SIL 15-TR-20
October 21, 2020
Page 1 of 6

SUBJECT: Release of Redesigned Torque Converter Components for 6630 ORS

MODELS AFFECTED: 6630 ORS

SERIAL NUMBERS AFFECTED: Beginning with S/N 3110122874

Figure 1. Current Turbine Assembly and Former Turbine Assembly.

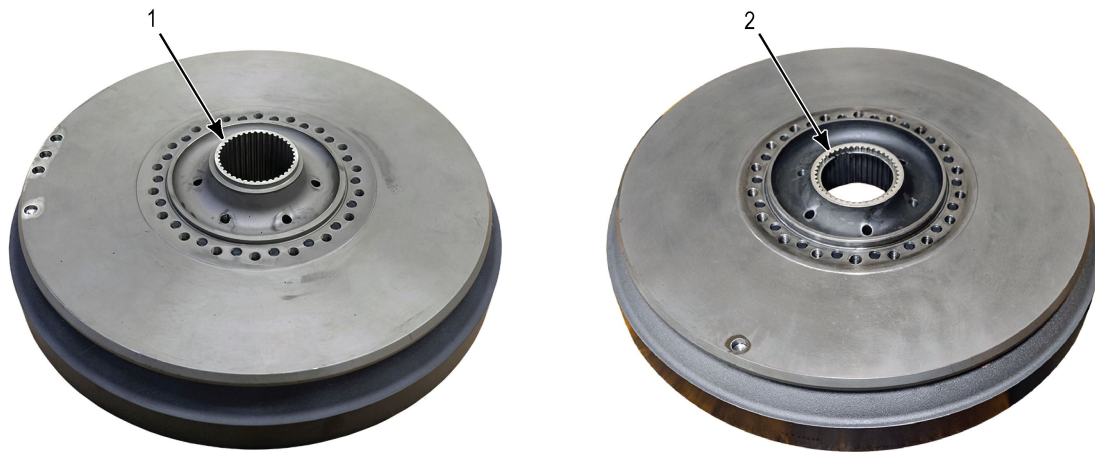
The current turbine assembly does not require a retaining ring to be installed to the splined inner diameter of the turbine hub. The current turbine assembly can be identified by the absence of a retaining ring groove in the splined section of the hub. The redesigned turbine hub also features a self-locking internal thread form for the damper bolts that provides increased thread locking capacity. Refer to [Figure 1](#).

Item	Description
1—Current Turbine Assembly 29563209	No retaining ring or groove
2—Former Turbine Assembly 29557428	Retaining ring and groove

Figure 3. Torx Plus® and Internal Hex Bolt Head Geometry Differences

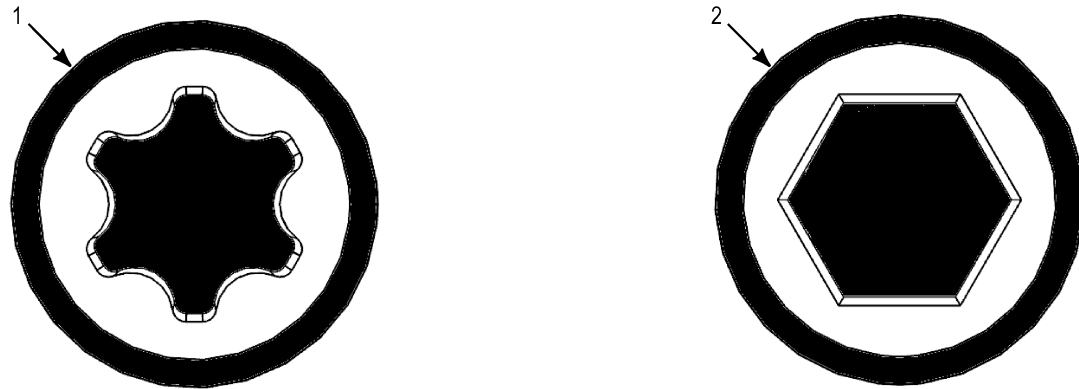
The geometry of the current damper bolt head has changed. The current damper bolt requires a size 50 IP Torx Plus® driver to be used when removing and fastening. The former damper bolt utilized a 5/16-inch internal hex driver. The revised geometry of the damper bolt head enables the bolt to be more robust to the higher bolt torque requirement when installed to the current Turbine and Damper Assembly P/N 29563621. **The size of the bolt shank and thread pitch have not changed. The current Damper Bolt P/N 29565357 is fully interchangeable backwards with the former 6630 ORS turbine.** Refer to [Figure 3](#).

Item	Description
1	Current Bolt 29565357
2	Former Bolt 29557445

NOTE: The torque requirement for the damper bolts in the current turbine assembly has been increased compared to the former turbine assembly. When servicing the current turbine assembly, the bolts must be torqued to **58-70 lb ft (79-95 N·m)**.

Figure 4. 6630 ORS Color Cross Section

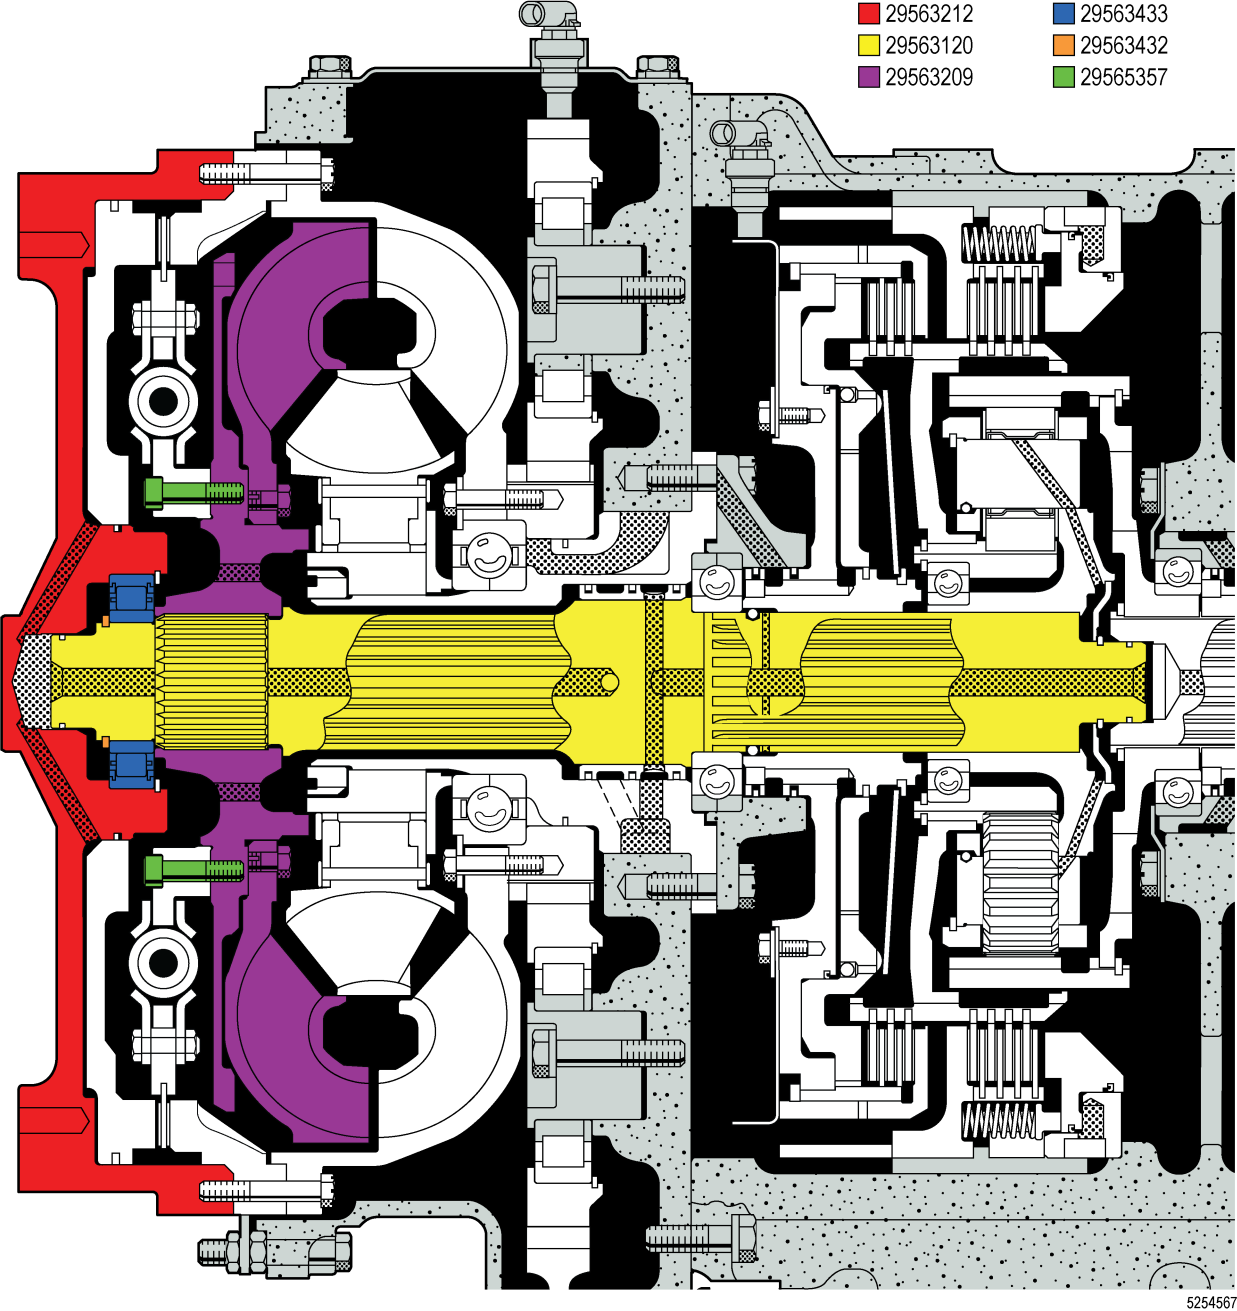
The new components of the 6630 ORS torque converter and turbine shaft are described in Table 1. New components are fully interchangeable backwards when used together. New components and former components cannot be mixed.

Item	Color Code (Refer to Figure 4)	Description	Current P/N	Former P/N	Qty
1	N/A	Turbine and Damper Assembly	29563621	29557432	1
2	Purple	Turbine Assembly	29563209*	29557428*	1
3	Green	Bolt, Damper	29565357**	29557445***	18
4	Red	Flywheel Assembly	29563212	29558384	1
5	Blue	Roller Bearing	29563433	23041452	1

Item	Color Code (Refer to Figure 4)	Description	Current P/N	Former P/N	Qty
6	Orange	Retaining Ring, Roller Bearing, Turbine Shaft	29563432	6838403	1
7	N/A	Turbine Shaft Assembly	29563609	29547653	1
8	Yellow	Turbine Shaft	29563120****	29544531****	1
9	N/A	Spacer	Not Used	29544559	1
10	N/A	Retaining Ring, Turbine Assembly	Not Used	29544524	1
<p>*29563209 Turbine Assembly is included in 29563621 Turbine and Damper Assembly. 29557428 Turbine Assembly is included in 29557432 Turbine and Damper Assembly. **29565357 Bolts are included in 29563621 and 29557432 Turbine and Damper Assemblies. ***29557445 Bolts have been completely cancelled and are replaced by 29565357 for all production and service needs. ****Serviced only as an assembly -- Not available as a detail part.</p>
